Critique of :

Effect of Wide Curb Lane Conversions on Bicycle and Motor Vehicle Interactions

Wayne Pein wpein@nc.rr.com

March 2005

Figure 5. [Note: Reproduced]

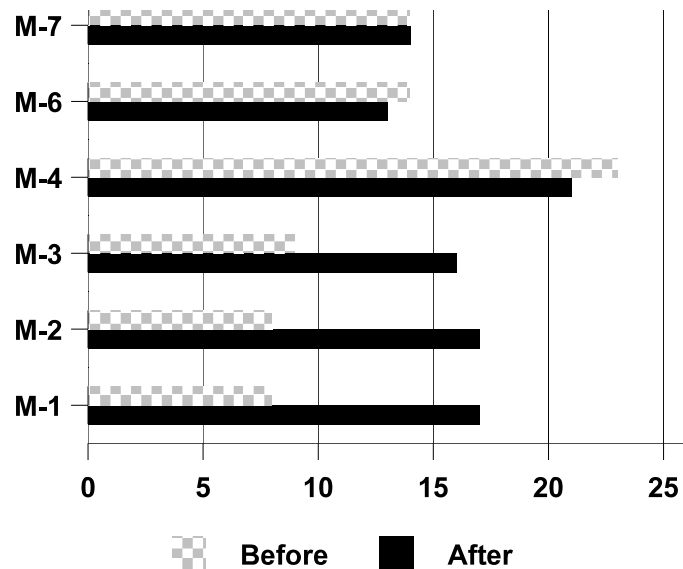
It would be expected that more experienced bicycle club members would operate farther left than typical bicyclists. As shown in Figure 5 on page 2 above, the School Resource Officers typically rode very close to the edge of pavement in the “before” period, 8-9 inches at sites M-1 to 3, and at times directly on the edgeline as can be seen in photos in Appendix A of the report. This indicates a very low knowledge of proper and defensive bicycling, in other words, riding skill. Figure 5 also shows that the bicycle club enthusiasts rode 23 inches from pavement edge at their M-4 “before” site, 14-15 inches further left than the School Resource Officers at their “before” sites M-1 to 3, and further left than the Officers at any of their “after” sites M-1 to 4.

As discussed earlier, the authors fail to acknowledge that “before” subjects at M-4, the more experienced bicycle club enthusiasts, rode an average of 23 inches from the edge line. This is 14-15 inches further from the edge line than the School Resource Officers at “before” sites M-1 to 3 (which also did not have a 3-foot stripe) and further from the edge line than any of the Officer subjects at any of the “after” sites with 3-foot stripe (see Figure 5 on page 2). This indicates that experience results in better lateral spacing than painting a stripe.
